Attachment A Comment Log

Substantive Public Comments Received – updated 11/14/2018

Figure 17C.110-A: Roof Types Eligible for Height Exception.

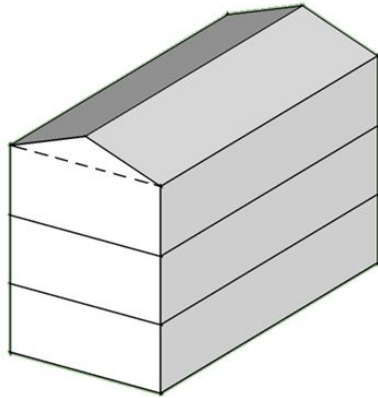
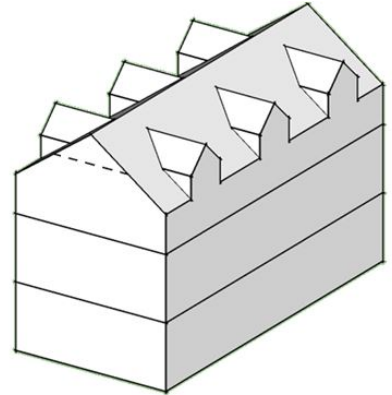
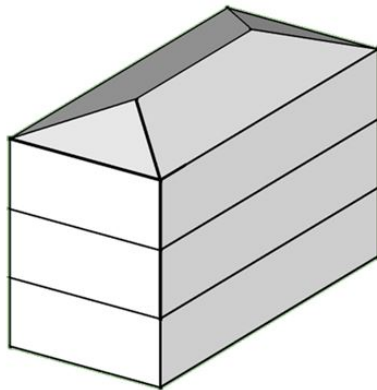
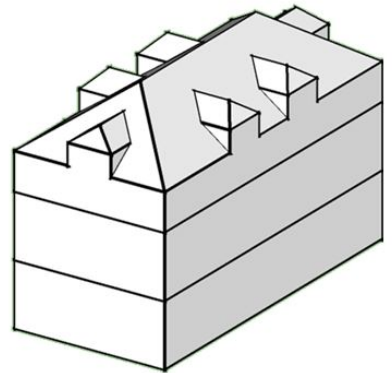
I recommend that the Plan Commission omit the new sections No. 2 and 3 which limit the type of roof forms which may be used. In the alternative change the height permitted in the MF zones to 50 feet. In addition add a provision to the MF design standards that requires that building height and massing be kept to two stories within 40 feet of a common boundary line with lower density SF zones.
